DEVIATION REQUEST AND DECISION FORM

Project Name : Saddlehorn Ranch – Filing 1
 Schedule No.(s) : 4300000561, 4400000562, 4300000556
 Legal Description : SEE ATTACHED – Exhibit B

A deviation from the standards of or in Section **ECM section 2.2.4 Figure 2-4 Rural Minor Arterial** of the Engineering Criteria Manual (ECM) is requested.

SADDLEHORN RANCH DEVIATION
 REQUEST
 CURTIS ROAD SECTIONS
 JOB NO. 25142.02
 5/4/20
 SHEET 1 OF 1

Exhibit A

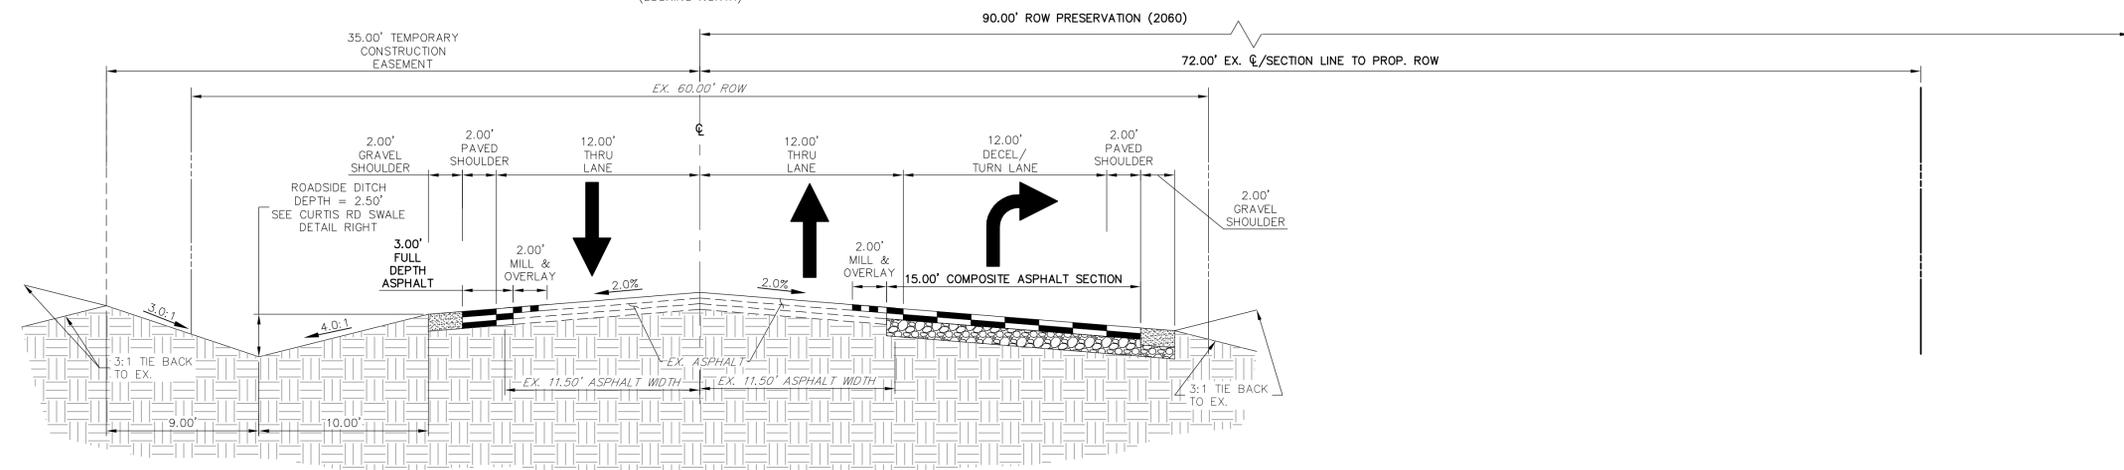
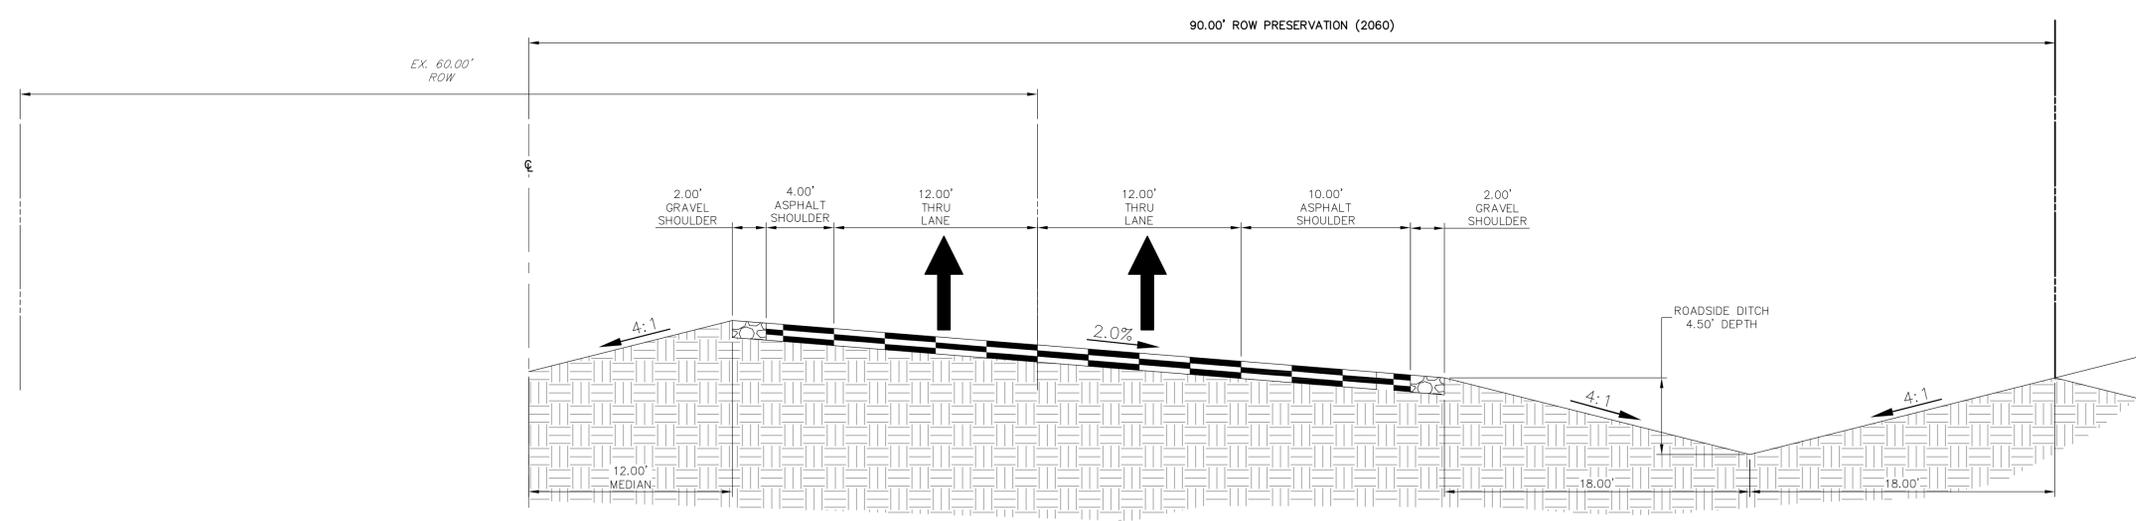
ECM criteria for a rural minor arterial cross sections requires a 12' travel lane and an 8' paved shoulder.

The reason for the requested deviation for the cross section of a rural minor arterial cross section is that ROW would need to be obtained from property owners to have the full 8' paved shoulder on the west side of the road. While the minor arterial cross section could be built on the east side of the road, it is not the appropriate time to build out the full section until both sides of the road can be constructed.

The proposed alternative is for the 8' paved shoulder to be reduced to a 2' paved shoulder. This is the maximum that can fit inside the existing western ROW. Exhibit A provides the proposed cross section.

ROW must be obtained on the west side of the road for the full 8' paved shoulder to be constructed on Curtis Road. The maximum shoulder width that can be constructed inside the existing ROW is 2'.

CURTIS ROAD - MODIFIED MINOR RURAL ARTERIAL
 STA: 1+05 - 10+40.09 & 15+82.58 - 30+81.13
 POSTED SPEED LIMIT = 45 MPH
 SCALE: 1" = 5'
 (LOOKING NORTH)

CURTIS ROAD - MODIFIED MINOR RURAL ARTERIAL
 STA: 12+42.36 - 14+94.72
 POSTED SPEED LIMIT = 45 MPH
 SCALE: 1" = 5'
 (LOOKING NORTH)
